**Action 19.4: Appendix 5 – WML Consulting Preliminary Land
Stability Assessment Clod Lane, Haslingden (Appendices 5 to 7)**

ROWLINSON CONSTRUCTIONS LIMITED
HOUSING DEVELOPMENT AT HASLINGDEN
FURTHER
REPORT ON THE STABILITY OF THE SITE

FURTHER REPORT ON THE STABILITY OF THE SITE

OCTOBER, 1980.

Fig. 16. Relationship between safety factor and probability of failure

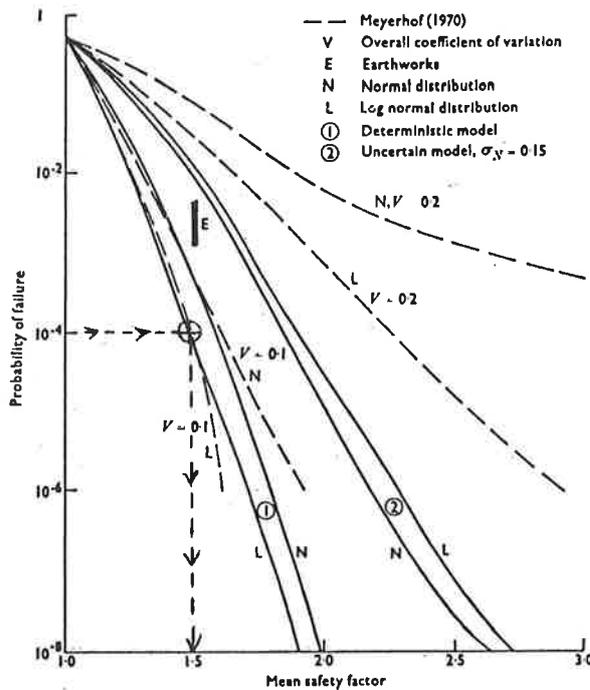
In clause 5.2.3.3. there is a discussion on the "Acceptable Levels of Risk" following which it is stated that "It is reasonable therefore, to expect that engineering structures should not have an annual risk failure of less than 10^{-4} ".

It is interesting to note that a recent analysis of this kind has related the mechanistic value of factor of safety to risk (Meyerhoff 1970) and (Alonso 1976). See Fig.16 below

From this it can be seen that for the level of risk quoted by Allott and Lomax (i.e. $< 10^{-4}$) the mean value of the factor of safety is 1.5.
